PJM Update to ISAC

Aaron Berner, Sr. Manager
Presented to Independent State
Agencies Committee (ISAC)
September 27, 2021

AEP Transmission Zone B3139 – B3141, B3220 Replacement

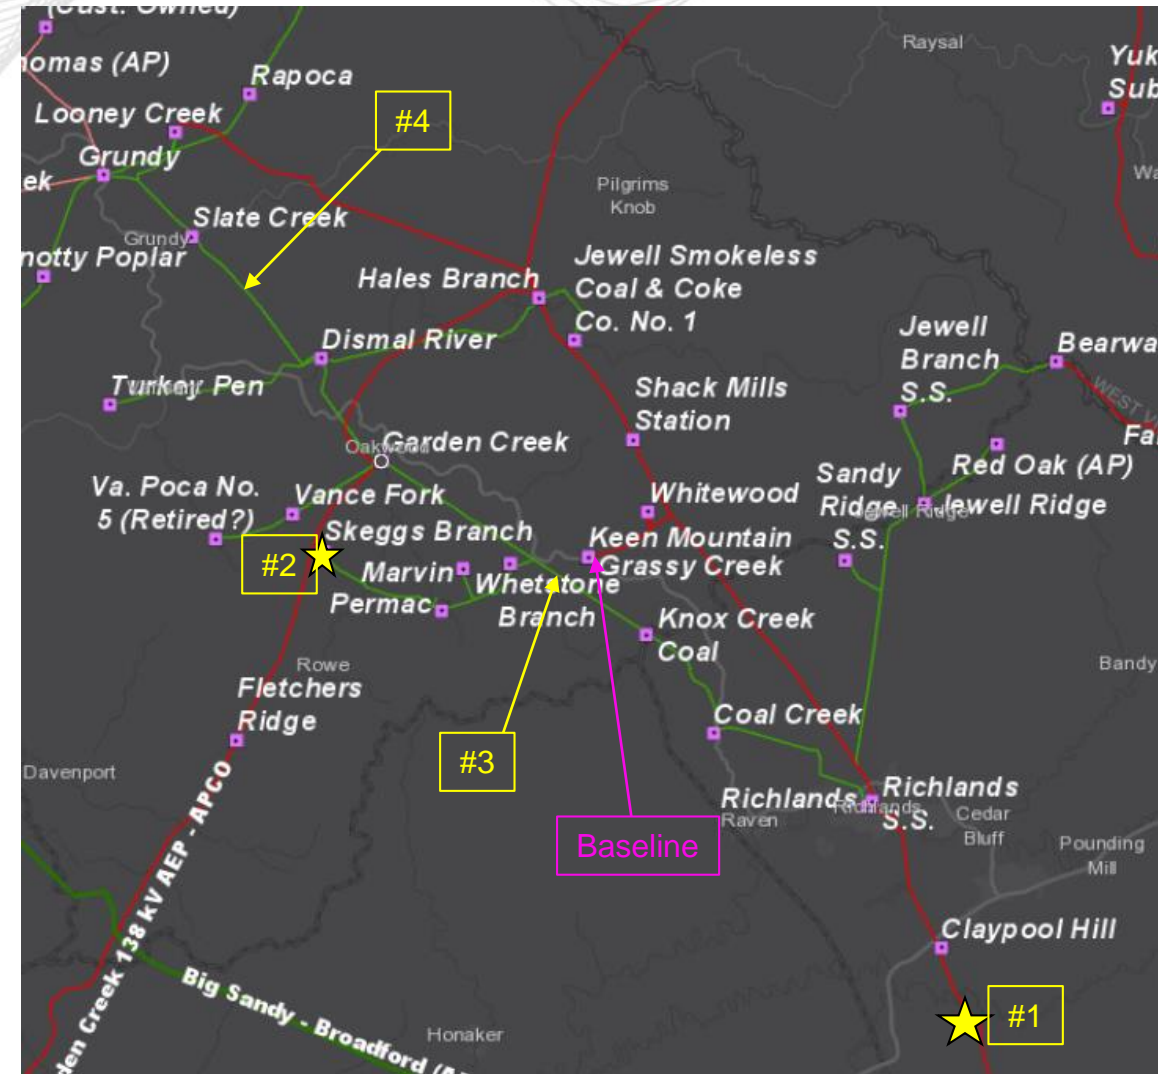
- **B3139:** Rebuild the Garden Creek - Whetstone 69 kV line (approx. 4 mile)
- **B3140:** Rebuild the Whetstone - Knox Creek 69 kV line (3.1 mile)
- **B3141:** Rebuild the Knox Creek - Coal Creek 69 kV line (2.9 mile)
- **B3220:** Install 14.4 MVAR Capacitor Bank at Whitewood 138 KV

Updated Projected IS Date: 12/15/2023

Reason for the delay:

- The schedule does not allow adequate time to complete the bat portal netting during September/October of 2021. This cannot be shifted to the next survey window due to the start of construction in July of 2022 to meet the current in-service date.
- The schedule does not allow for time of year restrictions for tree clearing due to endangered bat species.
